**CITY OF WEST DES MOINES
BOARD OF ADJUSTMENT COMMUNICATION**

Item: Sully's, 860 1st Street – Approval of a Permitted Conditional Use Permit for a drinking place with food sales – First Street, LP – PC-003365-2017

Requested Action: Approval of a Permitted Conditional Use Permit

5 FENCE DETAIL
1/4" = 1'-0"

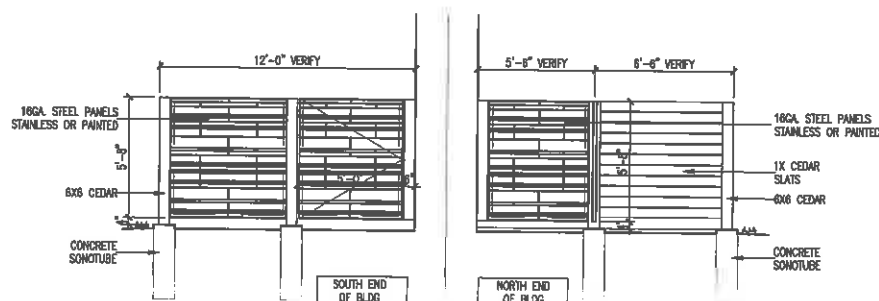
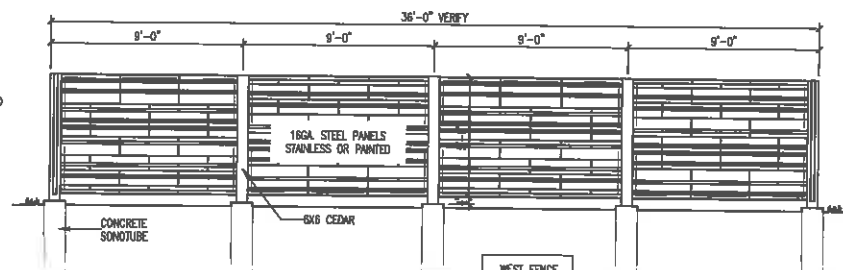
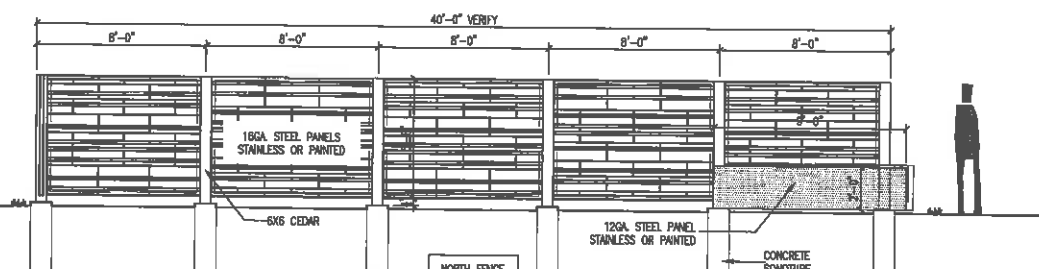
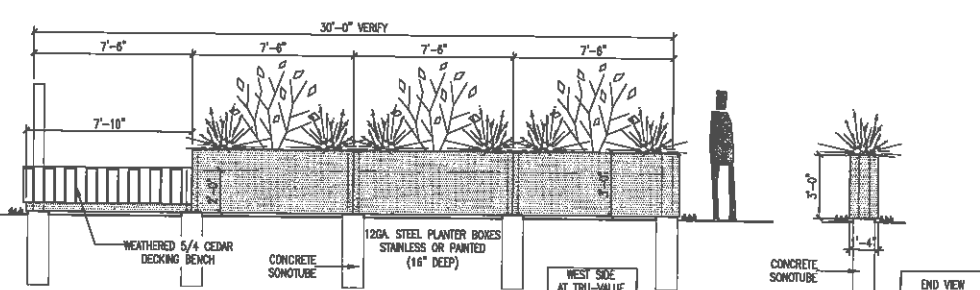
- **Screen Fence:** A fence is proposed at the southwest corner of the building that will screen a walk-in cooler addition on the west side of the building. This fence will be constructed to a height such that it completely screens the walk-in cooler. As of the date of this writing, the applicant hadn't obtained a product detail on the cooler to specifically state on the plans how tall the fence needs to be to completely screen the unit; therefore, a condition of approval is recommended requiring that the fence be constructed to a height to fully screen the cooler. In addition, staff is also recommending that a condition of approval be required that the applicant submit a material or paint sample of the material that will be used on the fence prior to a building permit being issued.

2. A material or paint sample for the chosen fence material that will be used for screening of the exterior portion of the walk-in cooler shall be provided for staff review prior to a building permit being issued for the site.
3. The screen fence along the south side of the building to screen the walk-in cooler shall be constructed to a height as necessary to fully screen the cooler.

2. A material or paint sample for the chosen fence material that will be used for screening of the exterior portion of the walk-in cooler shall be provided for staff review prior to a building permit being issued for the site.

3. The screen fence along the south side of the building to screen the walk-in cooler shall be constructed to a height as necessary to fully screen the cooler.
